CHANGES AND ADDITIONS TO MODEL 14 PARTS BULLETINS

<u>Type Bar Tape Printer (FP)</u>	<u>Typing Reperforator (FPR)</u>	<u>Reperforator Transmitter (FRXD)</u>	<u>Non-Typing Selector (FS)</u>
1028B, Issue 2	1088B, Issue 2	1108B, Issue 2	1083B, Issue 1
1030B, Issue 2	1100B, Issue 2	1126B, Issue 1	1107B, Issue 1
1031B, Issue 3	1117B, Issue 2

FIGURE 2

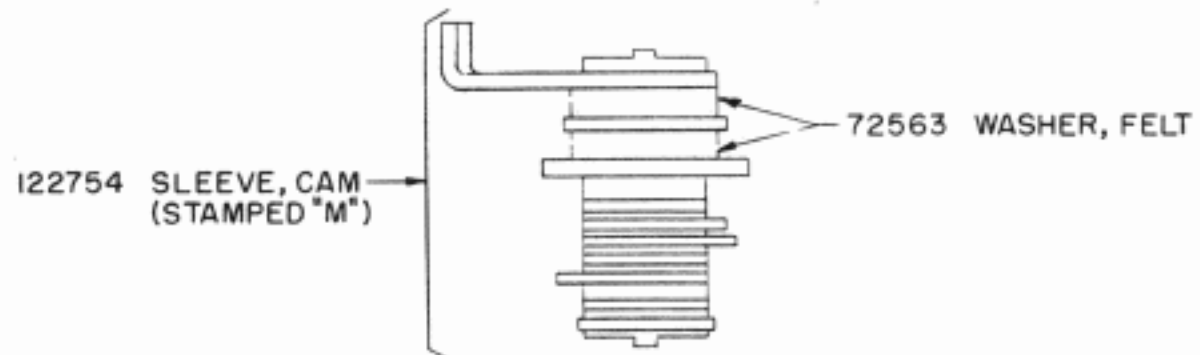
A 120553 friction disk assembly has been added to the main shaft assembly and is installed in the hollow of the main shaft gear. One of the 6746 screws and 2191 lock washers fastening the gear to the hub has been replaced by an 8543 screw which allows the button of the friction disk to mount in the hole in which the 8543 screw is used. The 72884 disk has been replaced by a 111686 disk. See Figure 2.

FIGURE 3

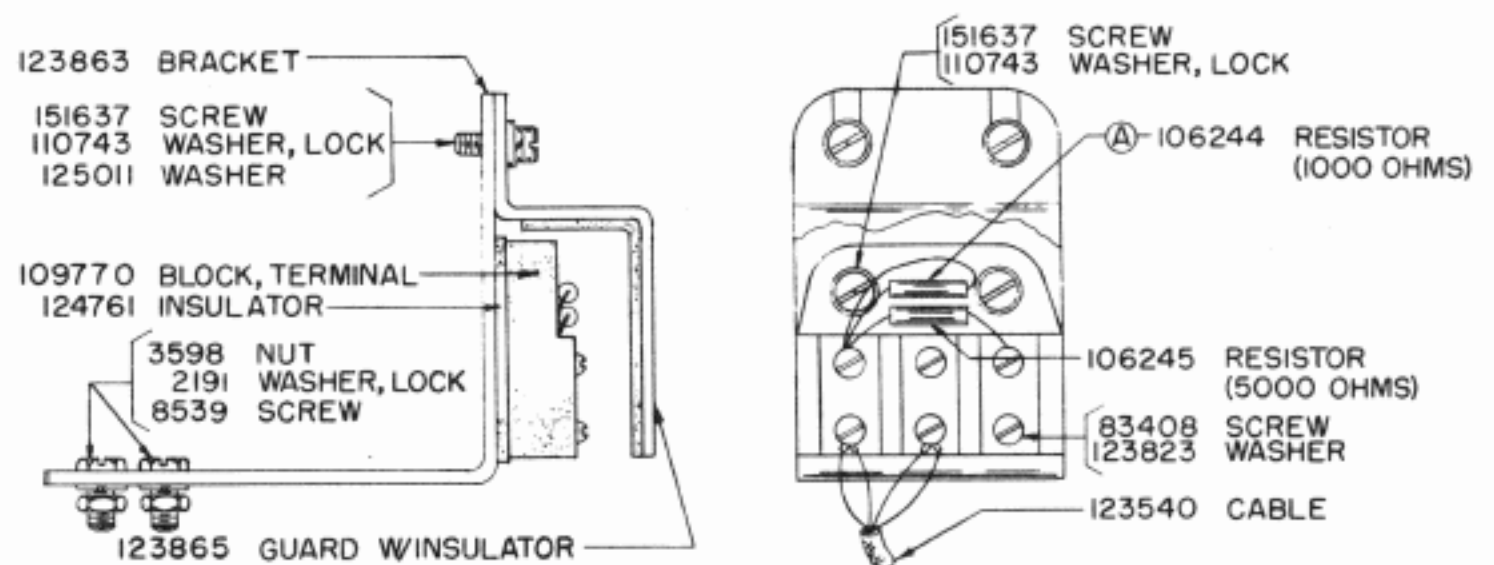
Two 72563 felt washers have been added to all cam sleeve assemblies used with holding type selectors. The 122754 (formerly 91265) cam sleeve assembly illustrated in Figure 3 shows the washers installed between the stop arm and armature lever cam and also between the armature lever cam and the locking lever cam. These washers are not a part of the cam sleeve assemblies and must be ordered separately.
